From: John Brazil
Sent: Sunday, April 9, 2023 10:49 AM
To: Hicks, Alison <Alison.Hicks@mountainview.gov>; Kamei, Ellen <Ellen.Kamei@mountainview.gov>; Matichak, Lisa <Lisa.Matichak@mountainview.gov>
Cc: Cameron, Dawn <Dawn.Cameron@mountainview.gov>; Lopez, Lorenzo
<Lorenzo.Lopez@mountainview.gov>
Subject: 4/10/23 CTC item 5.1 - include bike blvd elements

5.1 Latham Street Neighborhood Traffic Calming

5.3 Transit Center Grade Separation and Access Project update

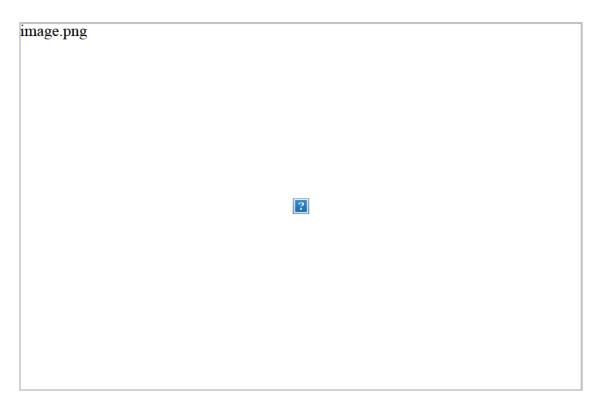
I might be as guilty of it as anyone but I think the community has not looked closely enough at the proposed ramp from Evelyn to Shoreline (that ramp alone represents a large portion

I am very concerned for the well being of any pedestrian or cyclist trying to go over the Shoreline overpass. As you can see from the image, they will need to deal with another complex intersection (at an incline) a mere few hundred feet after navigating another complex intersection at Villa. They will need to wait for yet another light (slowing down their journey) and watch carefully in every direction for dodging cars or buses making turns (including right on reds) in all sorts of directions. That traffic will also be primarily commute type traffic with drivers hurried to reach their office in time.

I'd like to consider some alternatives before someone gets injured (or worse)

- Is the ramp actually needed? Once you realign Evelyn, Evelyn will become the favored route to cross Castro to get to/from the transit Center. Couldn't the traffic then proceed to Villa via Franklin?

- Assuming you keep the ramp and its large cost, please consider making it a bus/shuttle/emergency services ramp only with the rest of the traffic going to/from Villa via Franklin. This would limit the traffic, the risks and the wait time for the pedestrians and cyclists along Shoreline. This would also speed up mass transit (an important goal for the City as demonstrated by the City investment in a reversible bus only lane at the other end of Shoreline). A win win?

Finally, the report asserts that one benefit of the ramp would be to limit Villa street traffic across the Castro pedestrian mall. I don't think it's accurate, once Evelyn is realigned, transit center traffic will cross Castro via Evelyn regardless of the ramp as it's a much more direct route. Also, to encourage more traffic to use the newly aligned Evelyn Avenue, the City could simply limit Villa crossing Castro to bikes. This would then also eliminate the need for a cumbersome traffic light for pedestrians enjoying the Pedestrian Mall. Another win win?
